**Service Bulletin**

Service Bulletin: SB 412-203

Subject: Bell 412 Air Conditioner Aft Evaporator Circuit Breaker Replacement.

Date: 9 July 1997

412 Air Conditioner Electrical Schematic

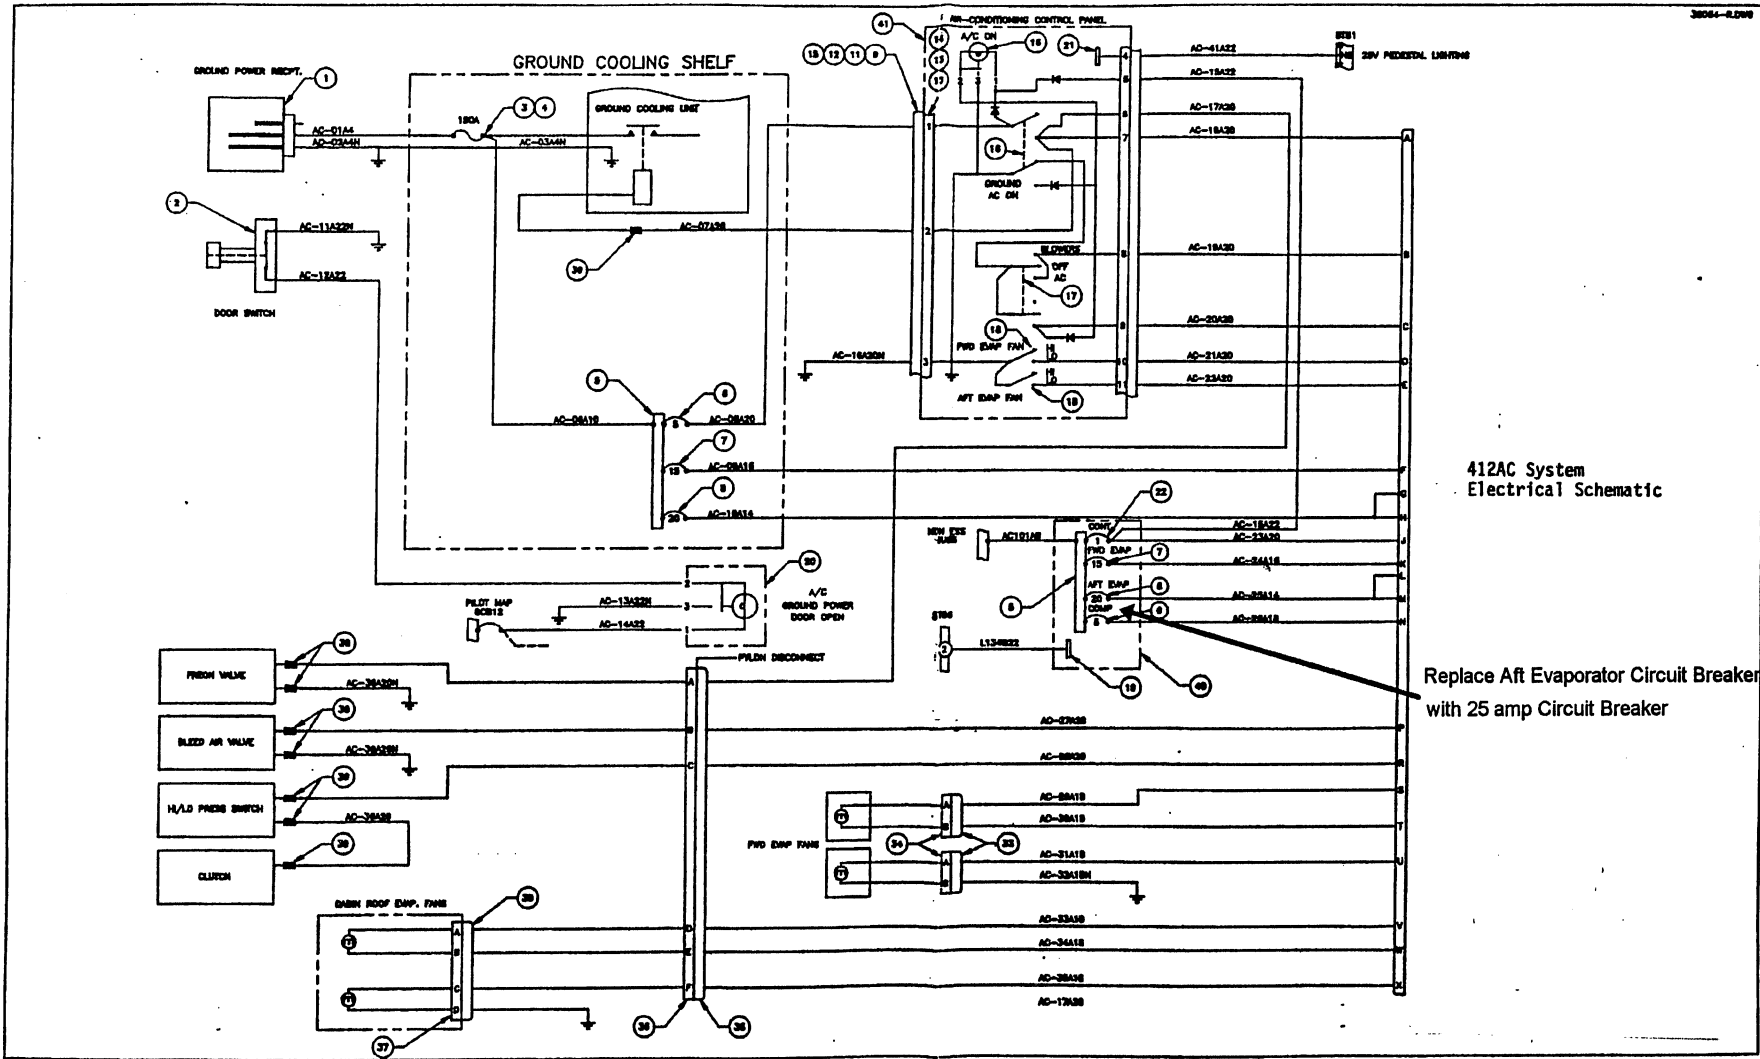
Replace Aft Evaporator Circuit Breaker with 25 amp Circuit Breaker
